Parts Bulletin

Group	Number	Version
P-37-1	1	01

Engine adapter harnesses, 14 pin

Models: Gas engines

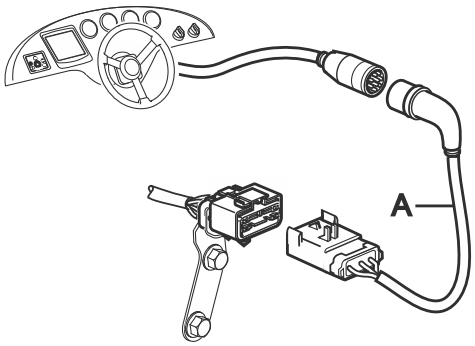
Beginning in May 2006 gas engines were produced with new sealed electrical connectors to connect the engine's electrical harness to the harness of the boat. The new connector has 14 pins and is rectangular. The previous connector was a molded round 10 pin connector.

Adapter harnesses have been released to help with common assembly issues due to this change.

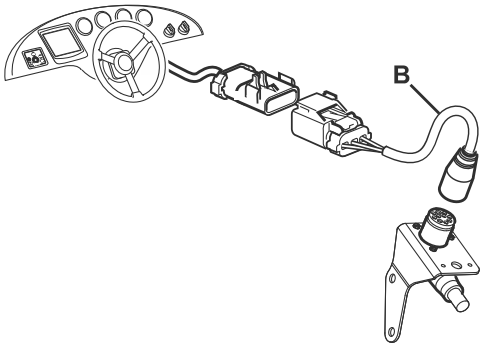
A. If engine has new 14 pin connector and boat is wired for earlier 10 pin connector, use adapter harness 3884406.

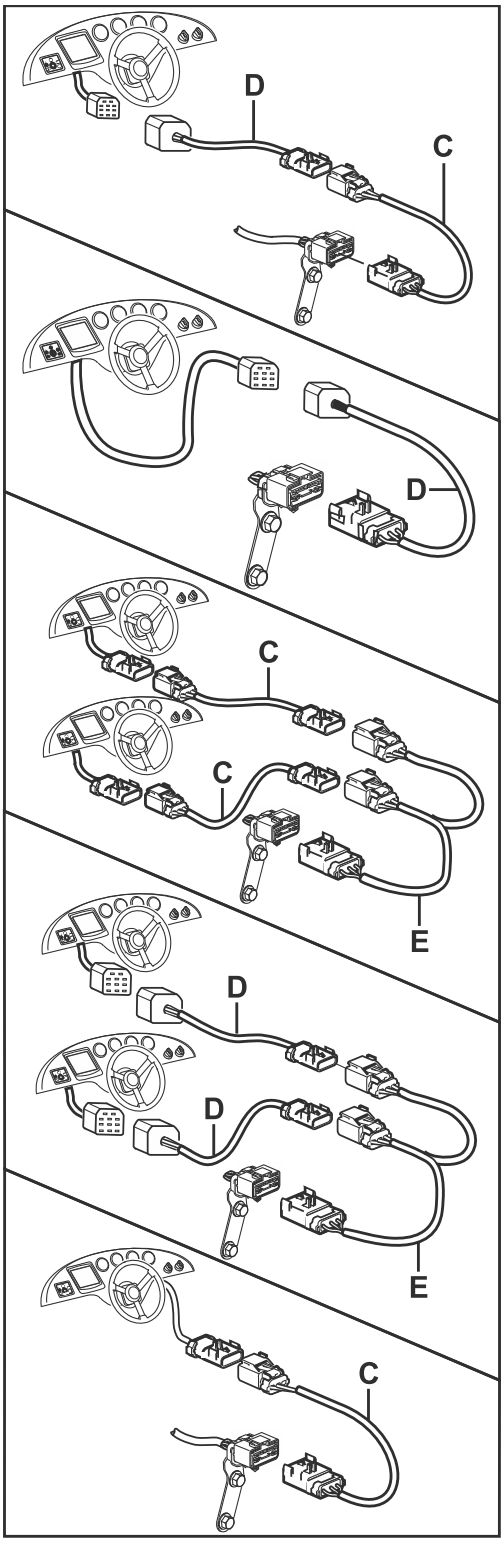
B. If engine has earlier 10 pin connector and boat is wired for newer 14 pin connector, use adapter harness 3888183.

C. Extensions, 14 pin to 14 pin

connectors are one male 14 pin, one female 14 pin

D. Extensions, 14 pin to 10 pin

Used to connect 14 pin engine harnesses to the 10 pin connector common on gauge panels and harnesses.

connectors are one male 14 pin, one female 10 pin

E. Dual station harness;

connectors are one male 14 pin, two female 14 pin
